PLANNING AND ZONING COMMISSION CONSIDERATION ITEM

CITY OF FAIR OAKS RANCH, TEXAS

AGENDA TOPIC: Consideration and possible action on a Concept Plan request from the applicant Urbanist Inc. on behalf of the property owners Brenda Minahan and Mark Minahan for a proposed multi-unit residential community on approximately 19.8 acres zoned Mixed Use Village District (MU). Generally located north-east of the intersection of Dietz Elkhorn Road Ralph Fair Road

Figure 7-1 Figure showing required building orientation and location of primary entrances

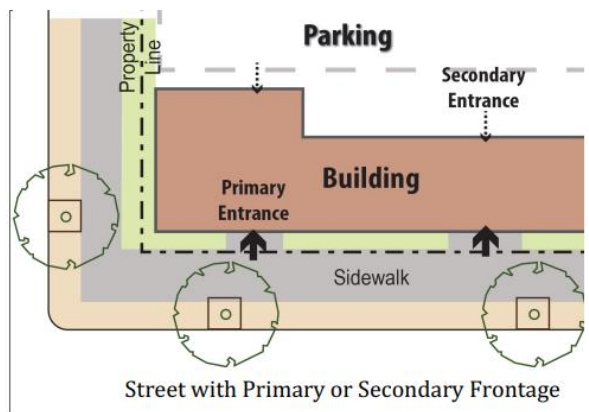
1. Newly added retail and restaurant uses do not meet the following requirements of the form based code:
 - a. Building Frontage: Minimum 40% of building frontage is not located between 10' min. -20' max. setback from the property line along Ralph Fair Road (Secondary Frontage) as required by the UDC.
 - b. Continuous pedestrian walkway to the entrances from the sidewalk on Ralph Fair Road to the building is not provided. (see illustrations from UDC below).
 - c. Parking is not located behind the principal building along Ralph Fair Road as per UDC 6.8 (1) d. (see illustrations from UDC below).

Figures 7-2 Examples of Primary Entrance Designs

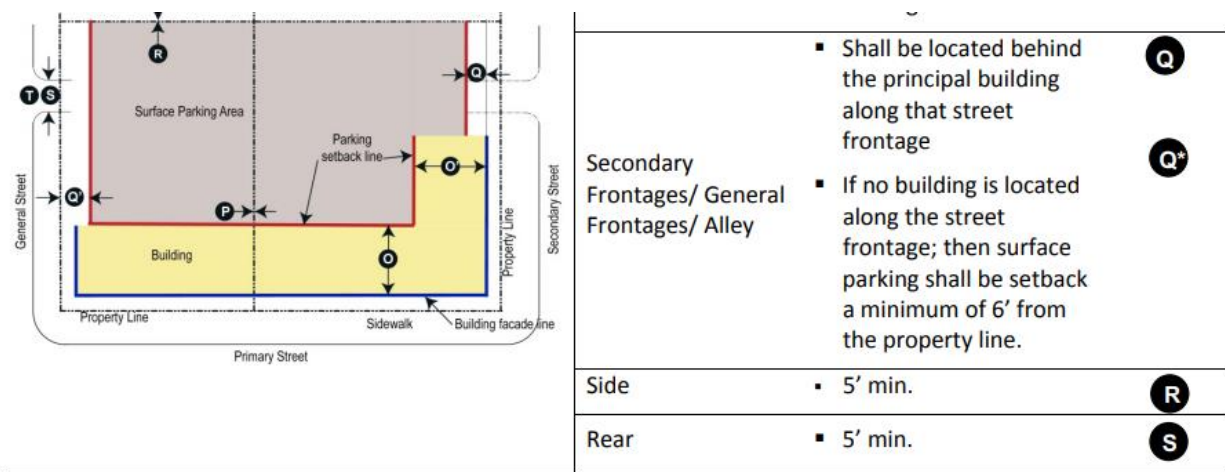
- analysis and land use table do not reflect the addition of retail and restaurant components.
3. The submittal does not include any plans or specific details showing conformance to the building design standards and landscaping standards required by the UDC. This information is required to confirm if the proposed development will meet the UDC requirements and the intent of the Comprehensive Plan. Examples of those requirements include:
 - a. Shaded sidewalk alongside at least 25 percent of the building facades with frontage along an off-street surface parking lot.
 - b. Building entrances along Ralph Fair Road is located under a shade device, such as an awning or portico.
